Village of Chenequa Plan Commission
Monday, July 8, 2024 at 6:00 p.m.
31275 W. County Road K, Chenequa, WI 53029

STAFF REVIEW

Subject: Site Plan Review

Project Description: Proposed Landscape Plan and Lighting Plan

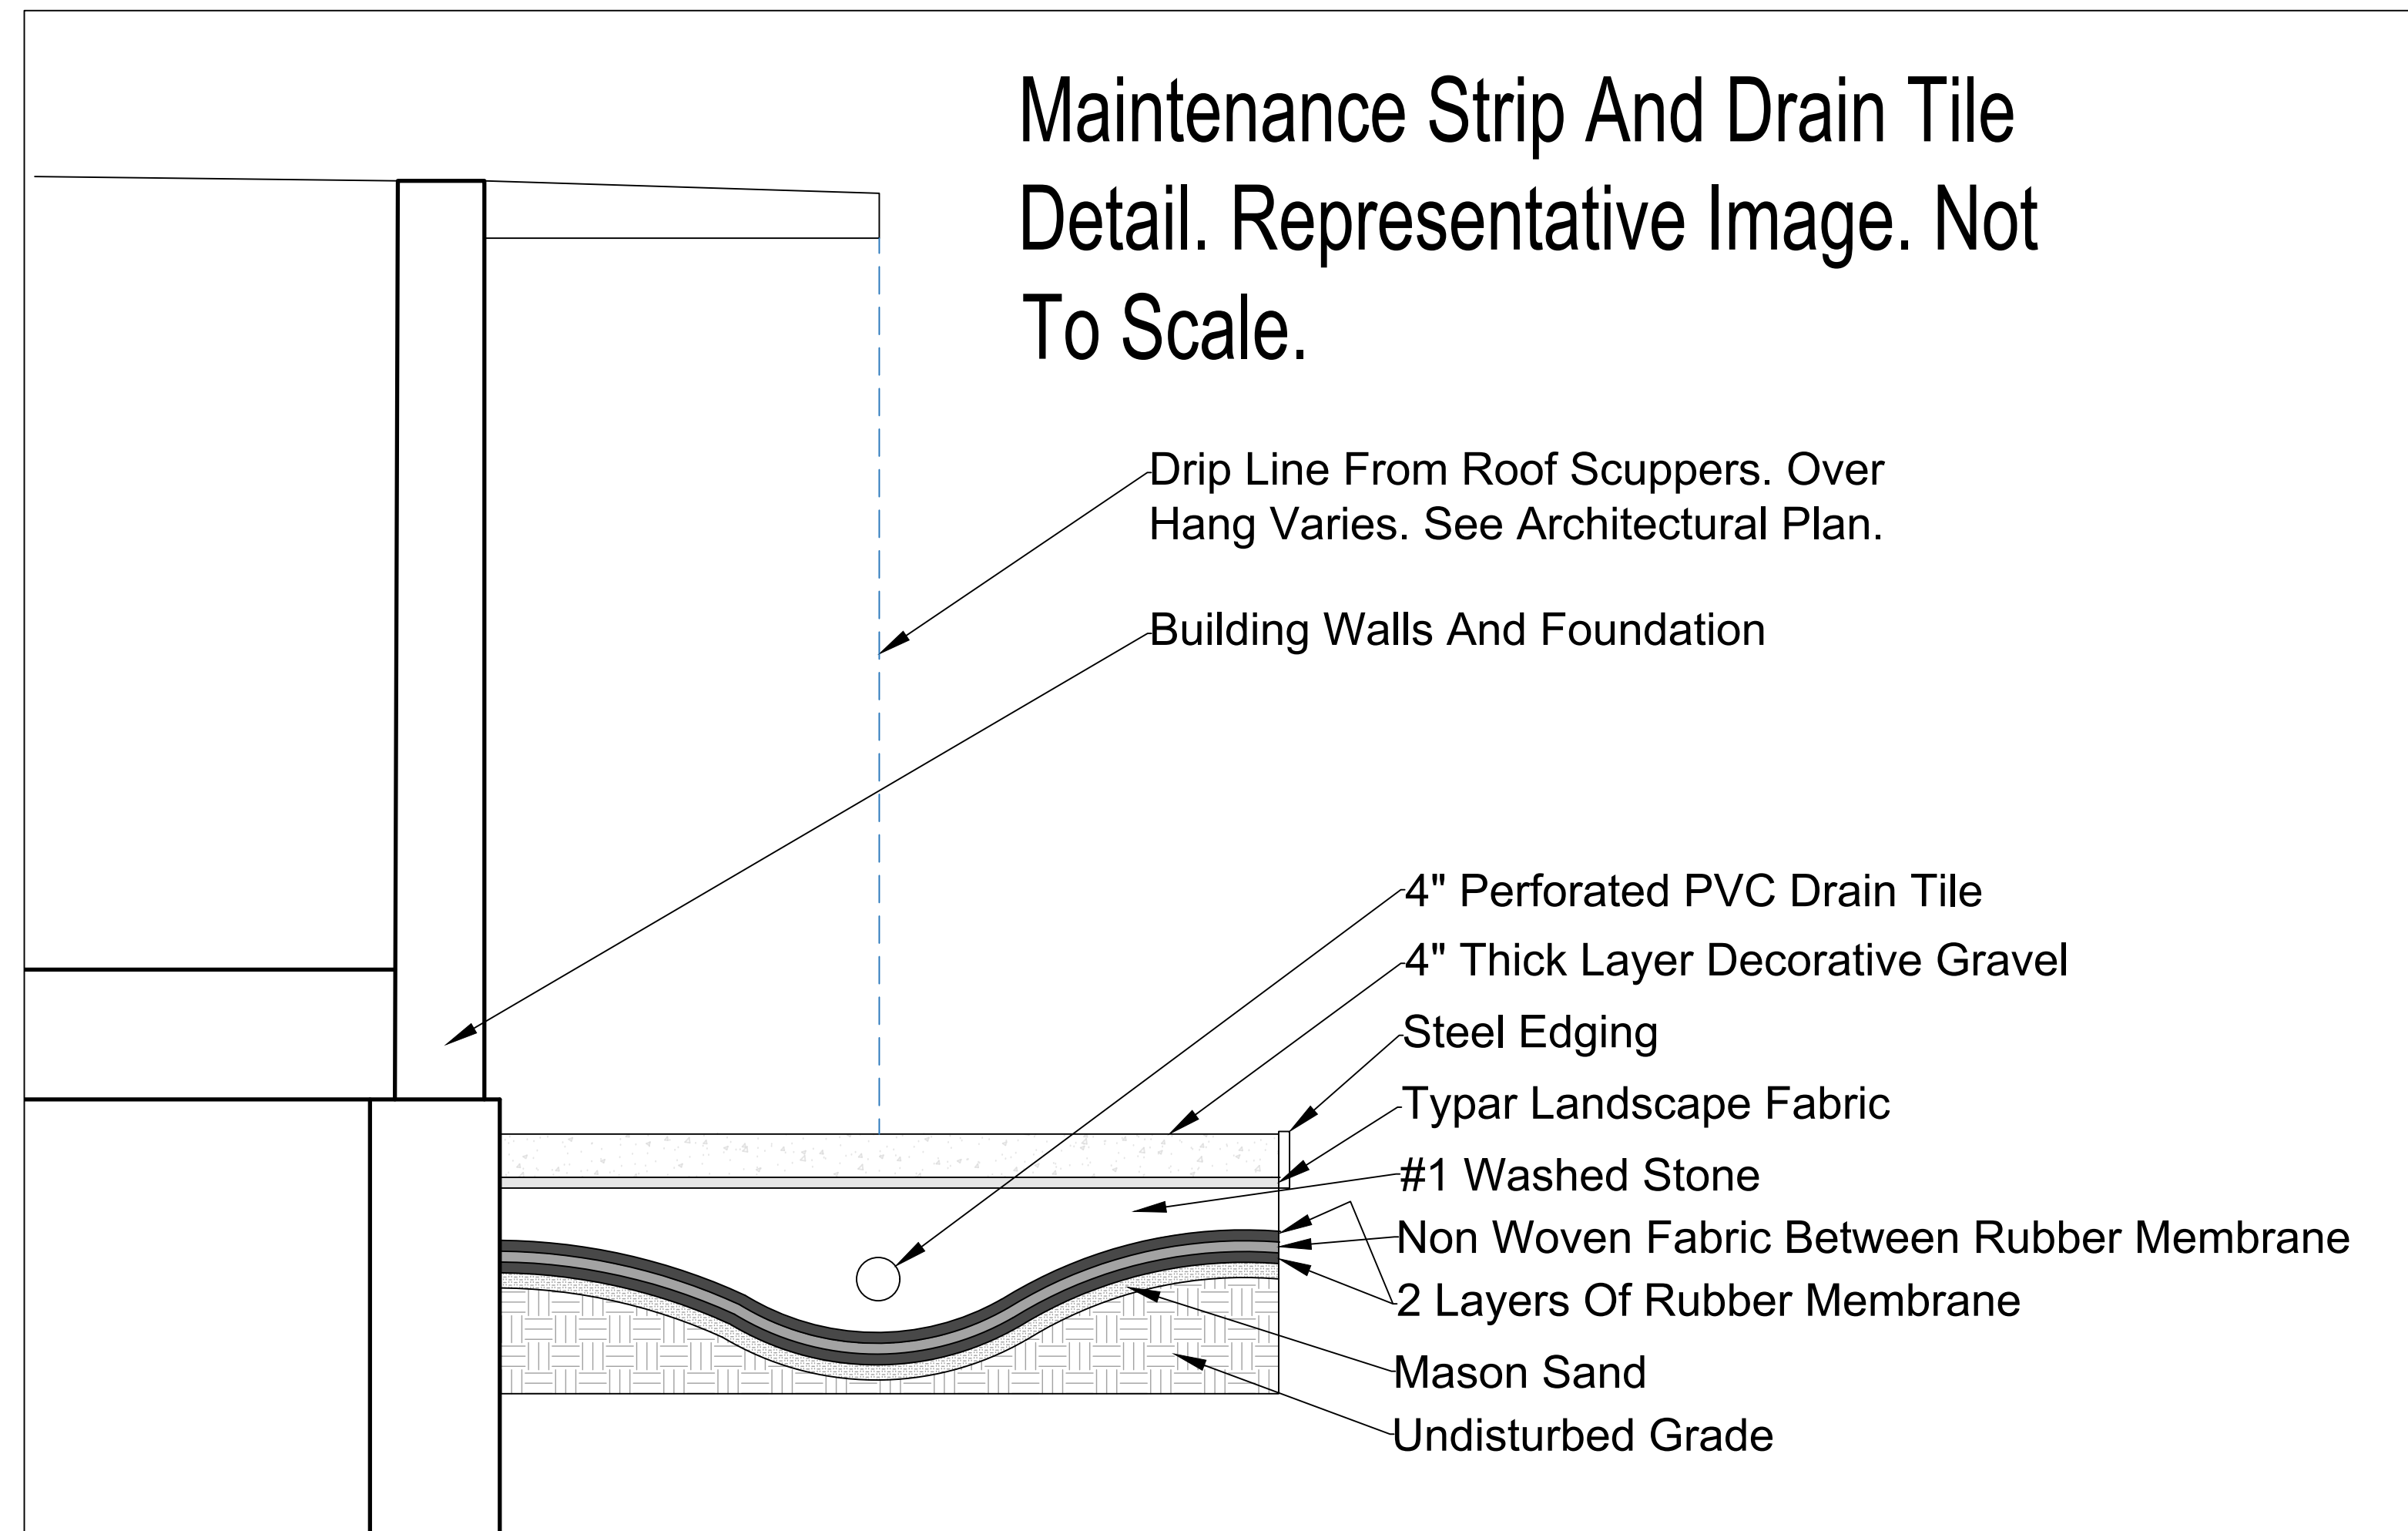
3. All proposed landscaping and landscape lighting is currently beyond the 75' setback from the OHWM of North Lake.
4. Landscaping includes;
 - One at grade patio on the lakeside of dwelling

- o This patio is entirely outside the 75' shoreland buffer setback.
 - o The patio is proposed to be constructed from "Full Range Bluestone"
 - o On this patio, the applicant is proposing to construct a firepit structure

- One at grade patio on the North side of the dwelling (with hot tub)
 - o The applicant is proposing to install an at grade patio labeled as a "Tranquility Terrace" on provided plans.

- o This patio is proposed to be constructed from "Full Range Bluestone"
 - o Included with this patio, the applicant is proposing an 8'X10' in ground hot tub.

- Roadside
 - Roadside the applicant is proposing a driveway court with a bluestone paver walkway.
 - There is an additional small covered patio shown on the plans near the courtyard. (This patio will also be constructed from “Full Range Bluestone”)
 - Headed southward from the courtyard, the applicant proposes a bluestone path with gravel infill between the pavers.

- Retaining walls
 - The applicant is proposing several “Snapped Limestone” retaining walls around the perimeter of the structure.
 - These retaining walls are outside of the 75’ setback from North Lake
 - These retaining walls do not encroach on the minimum side yard setback requirements.

- Stormwater management
 - Around the perimeter of the home the applicant will be installing a “Gravel Maintenance Strip” with perforated PVC pipe to capture storm water. This is in replacement to a traditional gutter system.
